**OHIO TURNPIKE AND
INFRASTRUCTURE COMMISSION**

ADDENDUM NO. 1

**PROJECT NO. 43-18-05 (PART B)
BRIDGE REPLACEMENT
OHIO TURNPIKE OVER MILL CREEK BIKEWAY, M.P. 223.0
MAHONING COUNTY, OHIO**

**REVISIONS TO 43-18-05-PART B PLAN SHEET NOS. TITLE, 2, 3, 5, 6, 7, 8, 9, 12, 13, 15, 20, 21, 22,
23, 24, 27, 30, 31, 32, 33, 37, 43, 44, 46, 47, 48, 49, 50, 56 AND 57 OF 57**

MAINTENANCE OF TRAFFIC STAGE 2	NO. 1	BY DATE	DESIGN AGENCY
	CHECKED	ADDENDUM #1	Gannett Fleming
DESIGNED	NO. 1	BY DATE	OHIO TURNPIKE
DRAWN	IN/CHARGE	VDT 8/18/18	OHIO TURNPIKE
PROJECT 43-18-05B	DATE: 4/27/18	8	OHIO TURNPIKE
57

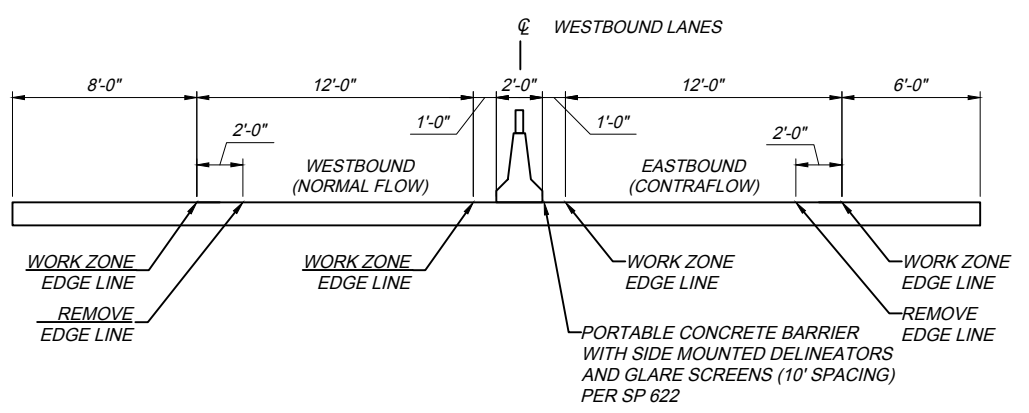
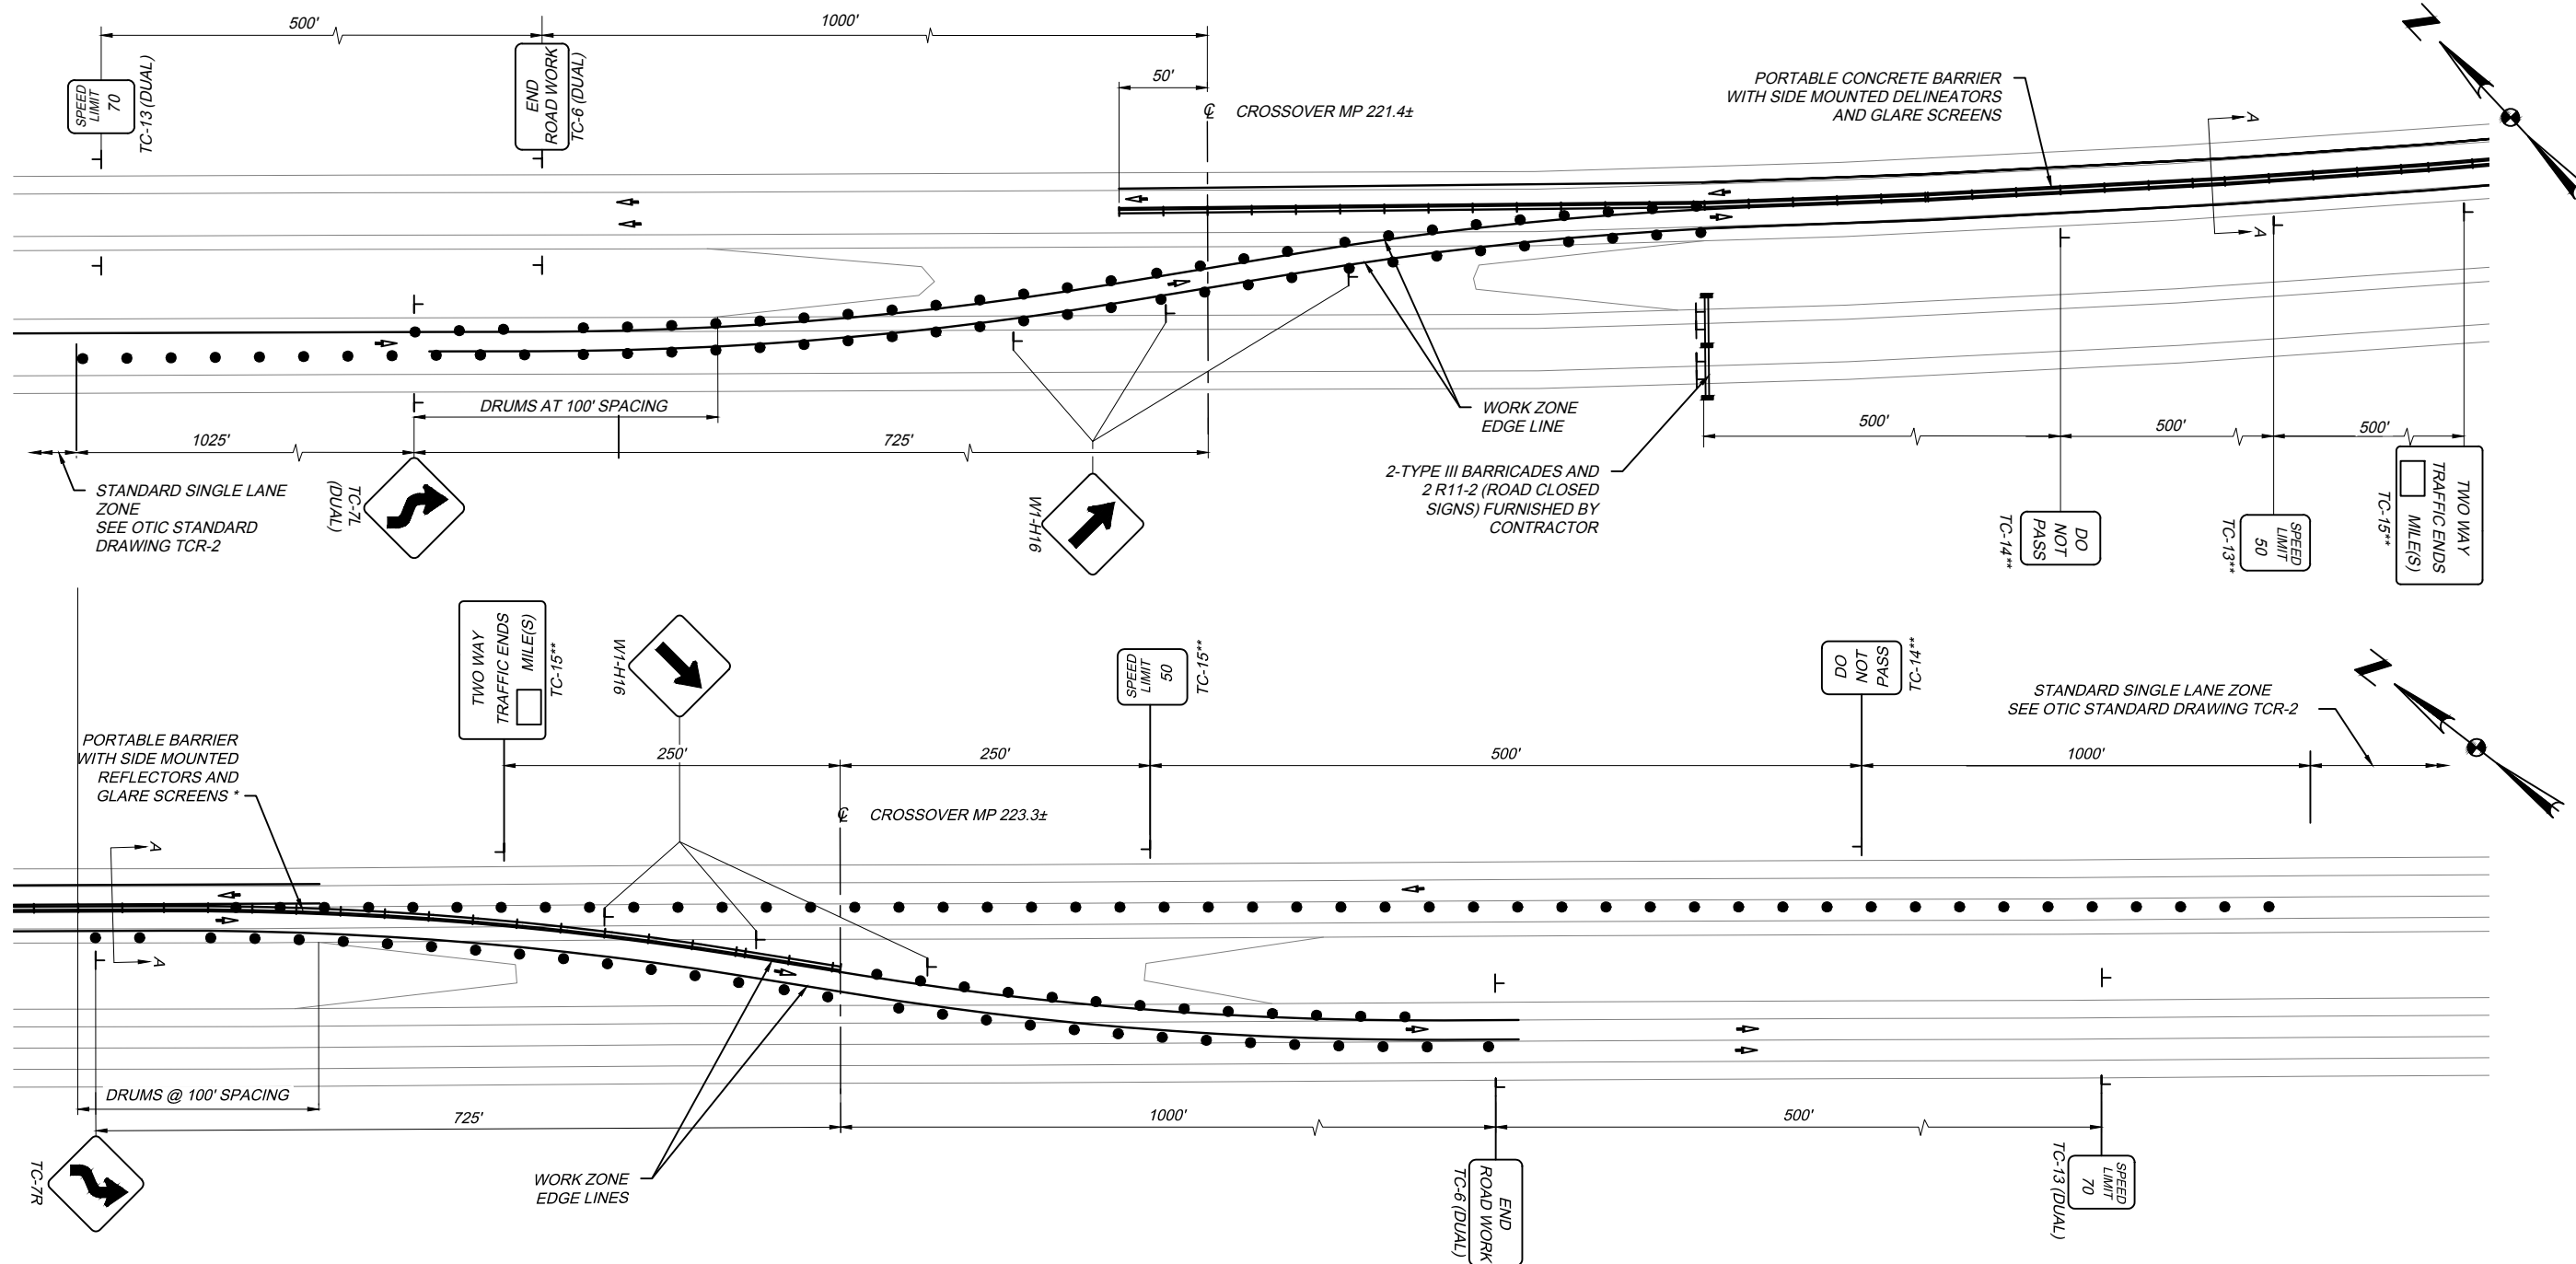
Q#14 Does "Pre-Phase 1(Year 1)" correspond to Phase 1 and does "Phase 1 (Year 2)" correspond to "Phase 2"? The Maintenance of Traffic Sequence on page 6 of the plans lists the phases as "Pre-

Phase 1(Year 1)” and “Phase 1 (Year 2)”. Sheets 8 and 9 that are referenced in this note are listed as “Phase 1” and “Phase 2”.

A#14 See the response to Q#8.

STAGE 1 - CONSTRUCTION
(LOOKING AHEAD)

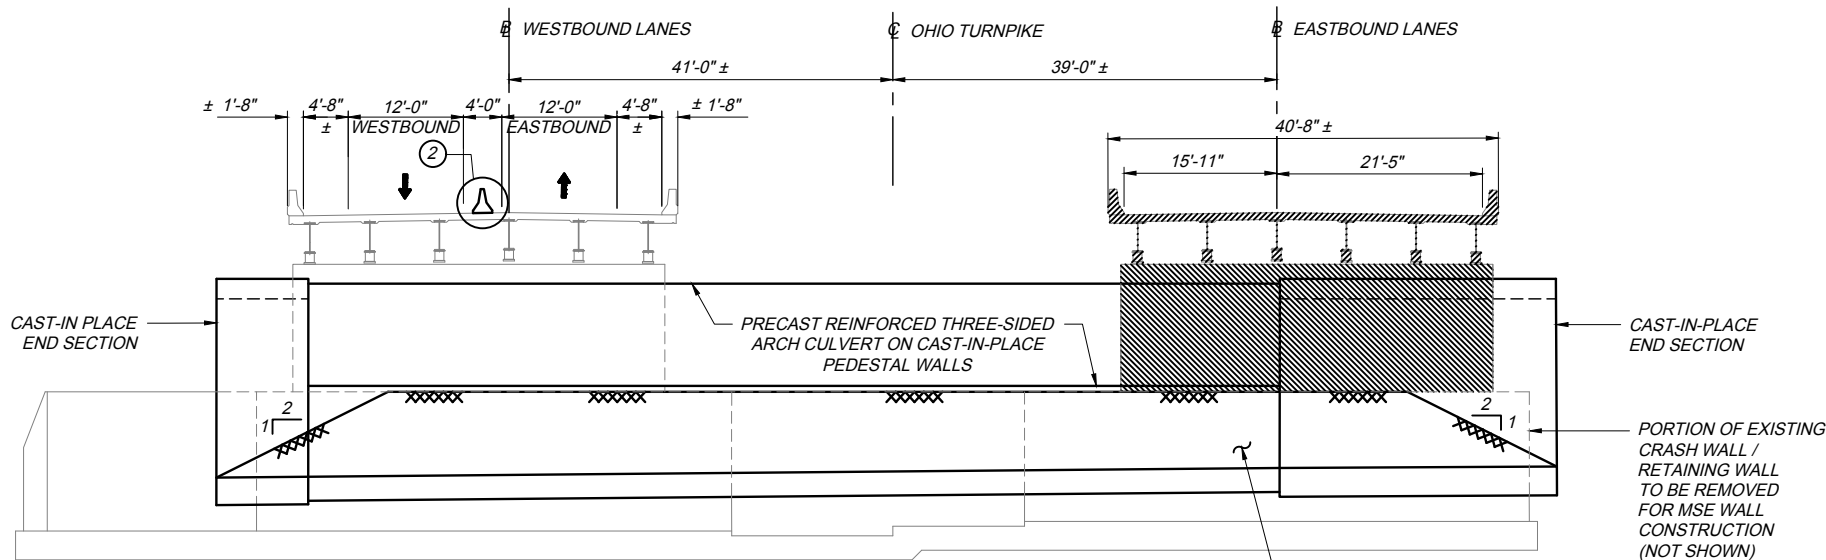
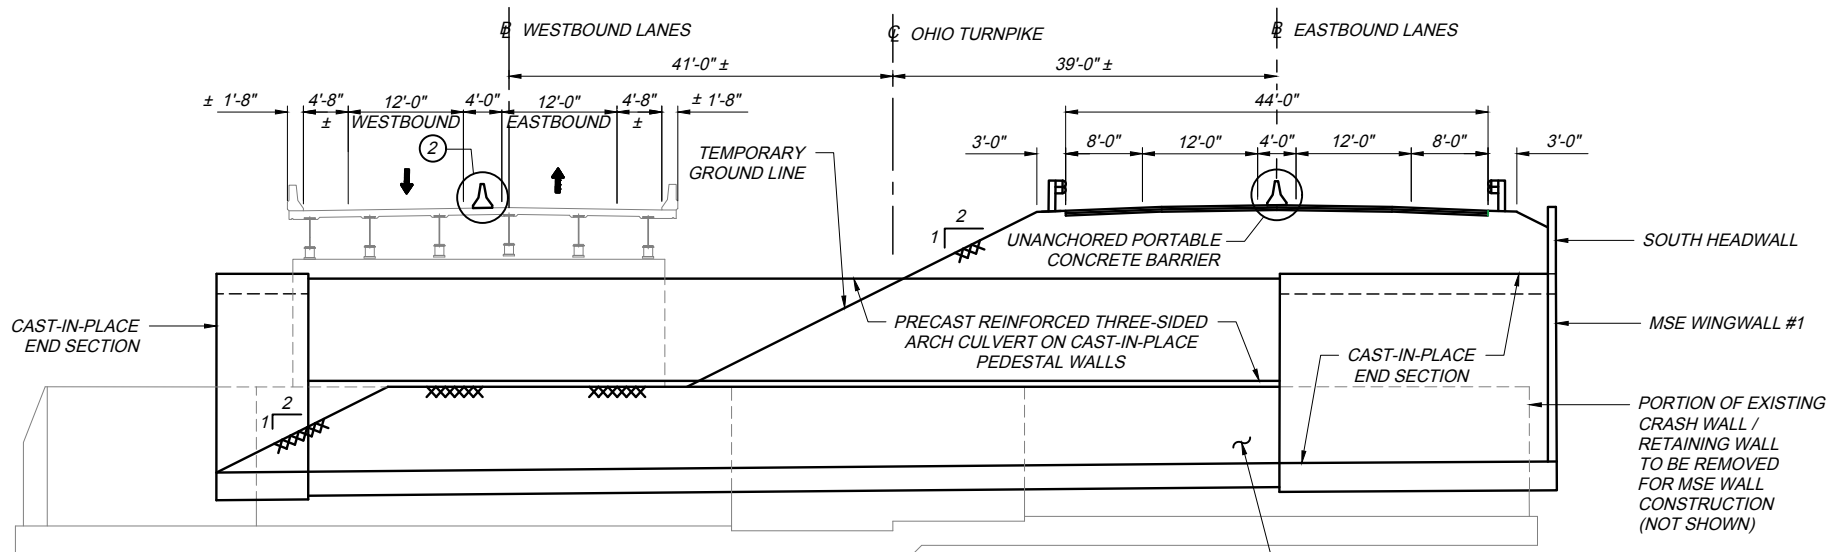
Also, the Stage 1 construction sequence on Plan Sheet No. 44 of 57 has been revised as follows:

- 1.) IMPLEMENT TEMPORARY TRAFFIC CONTROL ON OHIO TURNPIKE.*
- 2.) No changes.*
- 3.) No changes.*
- 4.) No changes.*
- 5.) No changes.*
- 6.) CONSTRUCT THE BIKEWAY DETOUR.*
